SERVICE LETTER 239

Cessna 206 Hydraulic Pump Replacement on 4000A Floats

Aircraft Makes/Model(s):	Float Model(s):	Compliance: Optional	By: MAS
Textron Aviation 206 Series	4000A	Part Number: 1011956	Approved: SDW
		Date: 9/21/2021	Revision: A

**DISCONTINUED OILDYNE HYDRAULIC PUMP
4A09000-081**

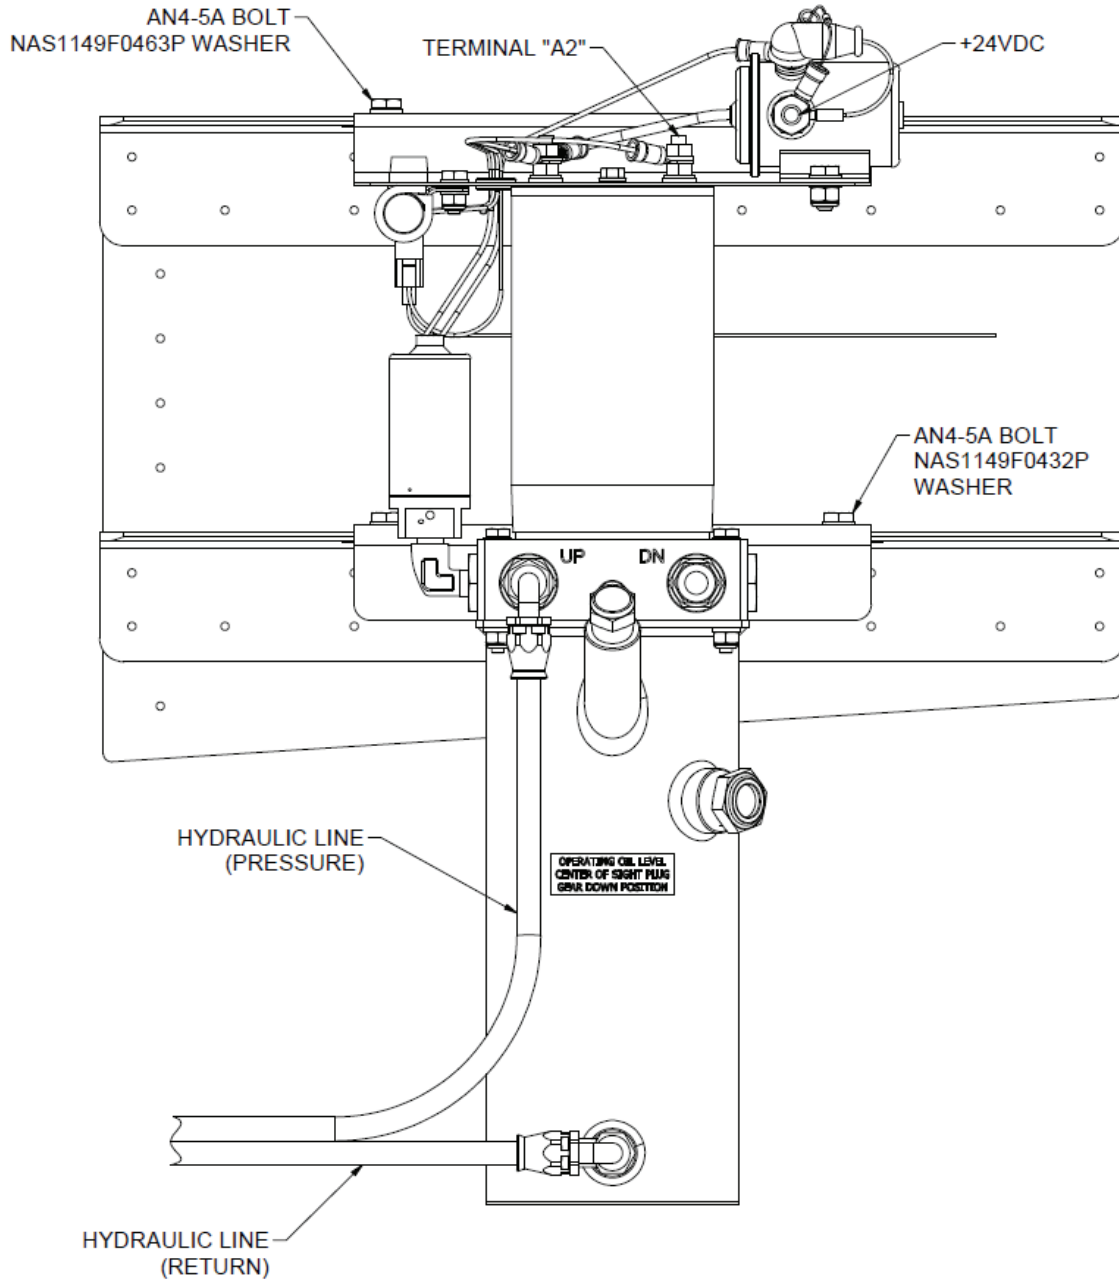
Textron Aviation (Cessna) 206 Hydraulic Pump Assembly 24 VDC p/n 4A09000-081 has been discontinued. This service letter provides the option to replace it with pump p/n 1011955 for the 24 VDC.

**NEW HYDRAULIC PUMP
1011955**

HYDRAULIC SCHEMATIC

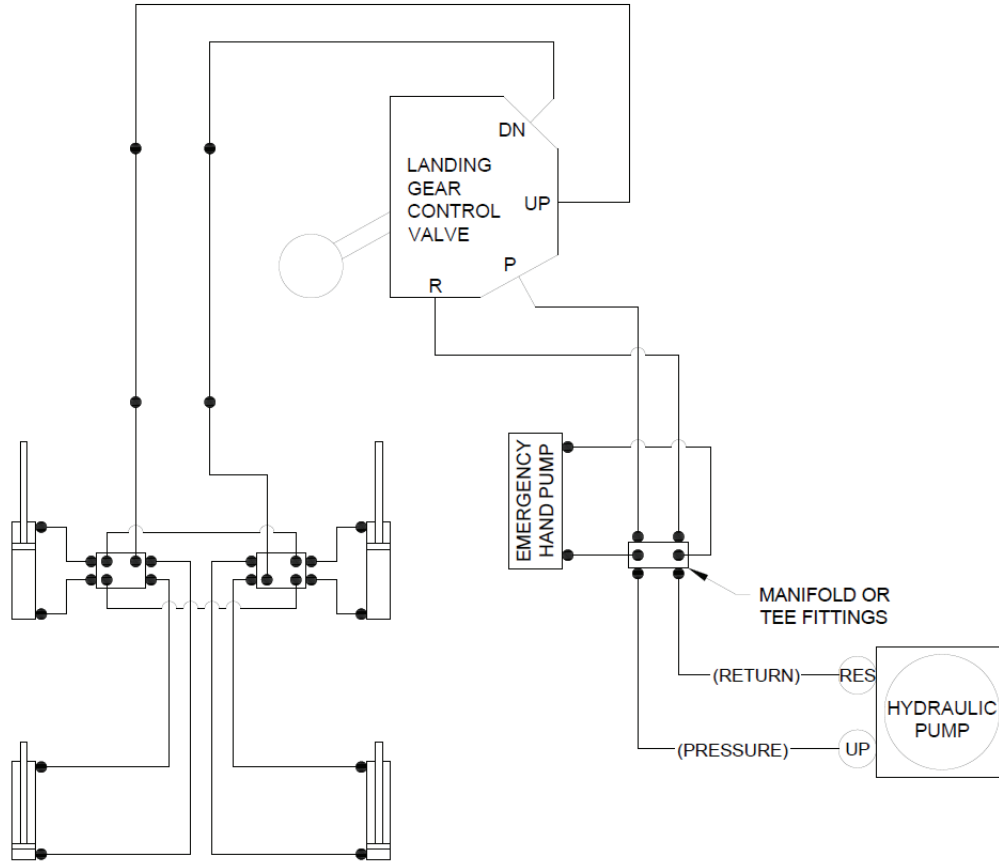
9. Install "pressure" hydraulic line into port "UP" of hydraulic pump assembly. See hydraulic schematic.
10. Install "return" hydraulic line into hydraulic fitting at bottom of hydraulic pump reservoir. See hydraulic schematic.

ELECTRICAL SCHEMATIC

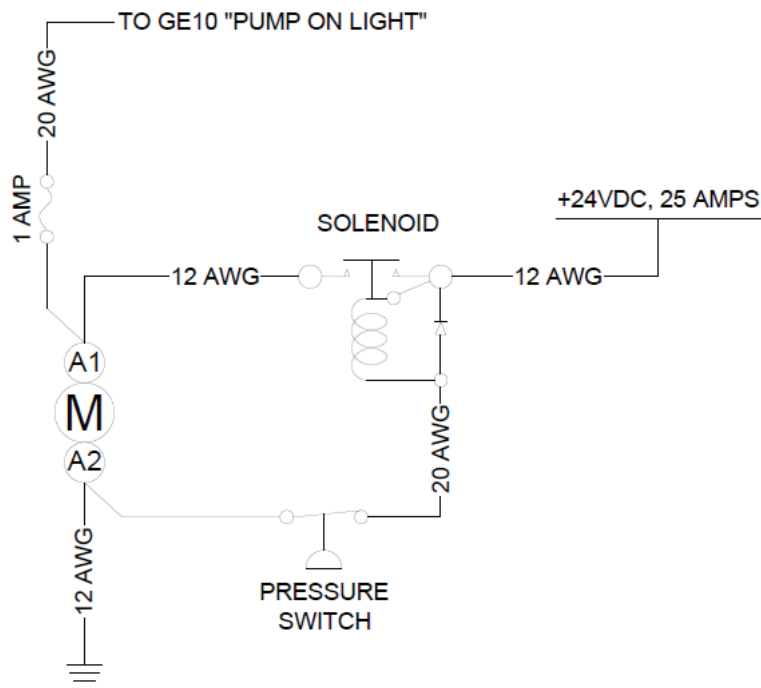
11. Make a ground wire from lug "A2" on hydraulic pump motor to aircraft ground with supplied 12 AWG wire and ring connectors. See electrical schematic.

12. Run the single open wire from hydraulic pump assembly fuse holder to "GE10" pump light on wire with supplied wire and electrical connectors. See electrical schematic.
